Date: August 3, 2011
File: 1200-40
To: City Manager
From: Signe Bagh - Director, Policy and Planning
Subject: OCP and Zoning Bylaw Amendments Relating to Downtown Plan Charrette

Date: September 9, 2011
File: TA11-0009/OCP11-0006
To: City Manager
From: Land Use Management Department, Community Sustainability Division
Subject: Text Amendment to Zoning Bylaw related to Downtown Plan Charrette

Date: September 28, 2011
File: TA11-0009/OCP11-0006 (LT)
To: City Manager
From: Land Use Management Department, Community Sustainability Division
Subject: Text Amendment to Zoning Bylaw related to Downtown Plan Charrette

Diagram 5.1

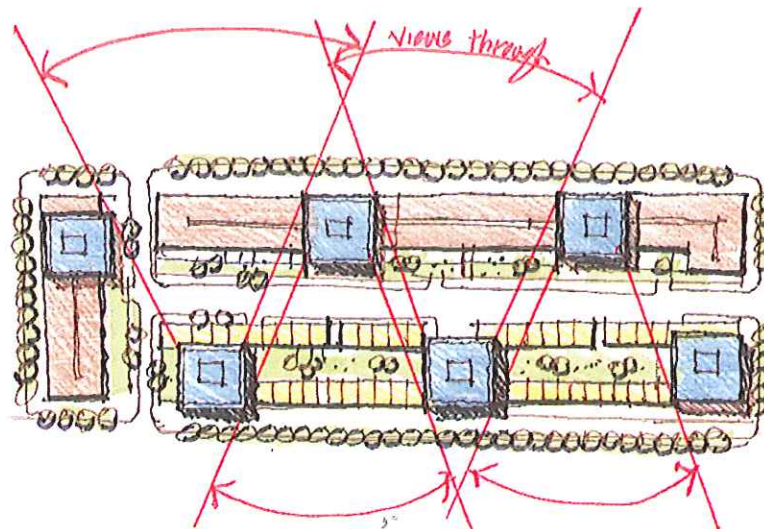
In addition, following Council discussion at the September 19 meeting, it is recommended that the following "Diagram 5.1" be added to the proposed Building Height Policy (5.5.1):

The above diagram illustrates the desired "checkerboard" pattern and sightline angles to be achieved for tall buildings through the revised wording of the Building Height Policy.

AND THAT Bylaw No. 10568 be amended at first reading, to include "Diagram 5.1" as shown in the report of the Land Use Management Department dated September 28, 2011;
